TECHNICAL INFORMATION

Subject ▶ Change of Crank Housing, etc.

For Models ▶ HM1801, HM1810

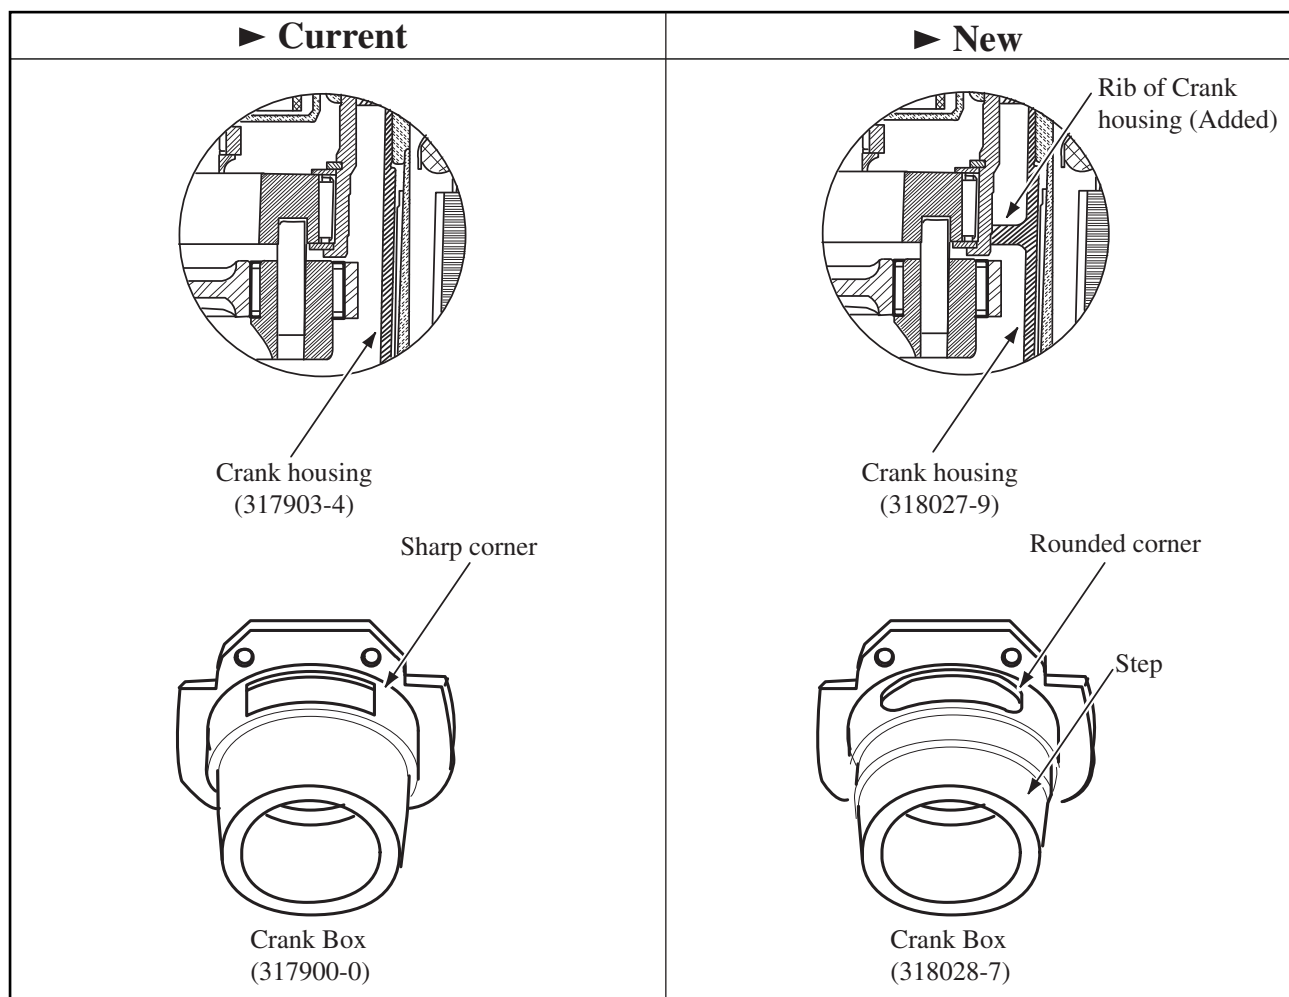
Description ▶ Crank housing of HM1801 and HM1810 has been changed as illustrated below.
Crank box of HM1810 has also been changed.

Item No.	Current part		Q'ty	I/C	New part		Q'ty	Note
031	Crank housing 317903-4		1	Yes	Crank housing 318027-9		1

Item No.	Current part		Q'ty	I/C	New part		Q'ty	Note
031	Crank housing 317903-4		1	No	Crank housing 318027-9		1	Interchangeable as a set
066	Crank Box 317900-0		1	←	Crank Box 318028-7		1
